May 4, 2026

ADDENDUM NO. 1

RE: Item #1, May 6, 2026 Letting - PH 0014(257)10, PCN 08LL, Lawrence County - Modify Intersection & Lighting

ESTIMATE OF QUANTITIES

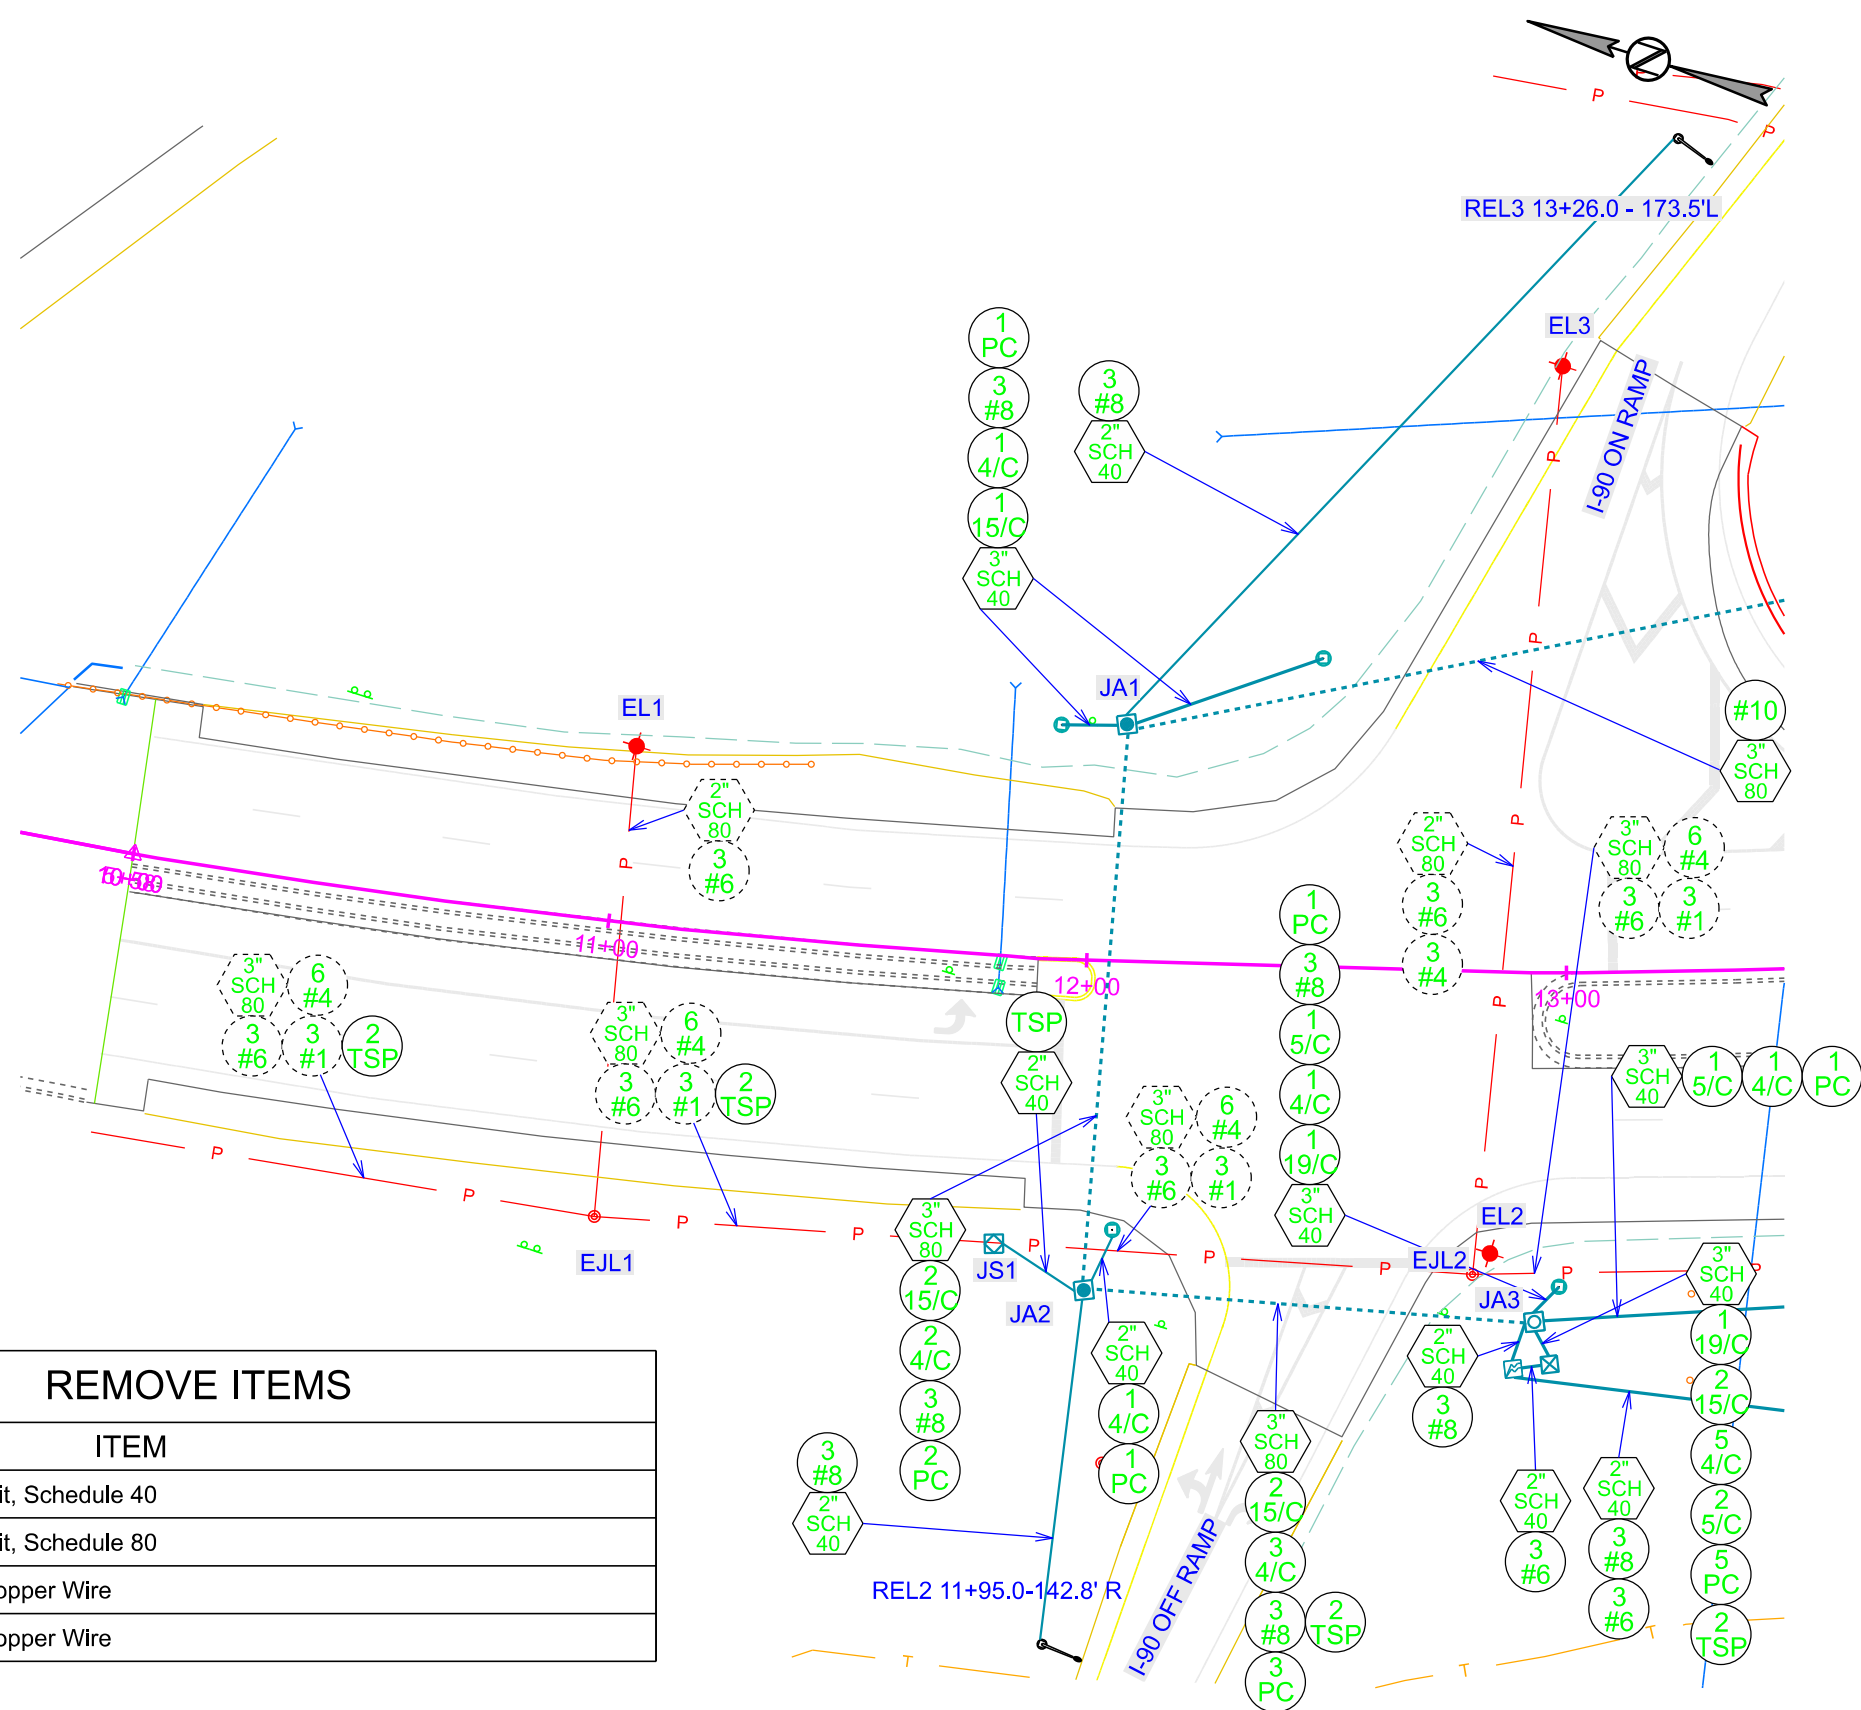
Sheet L9: ESTIMATE OF QUANTITIES & EXISTING ITEMS tables were revised.
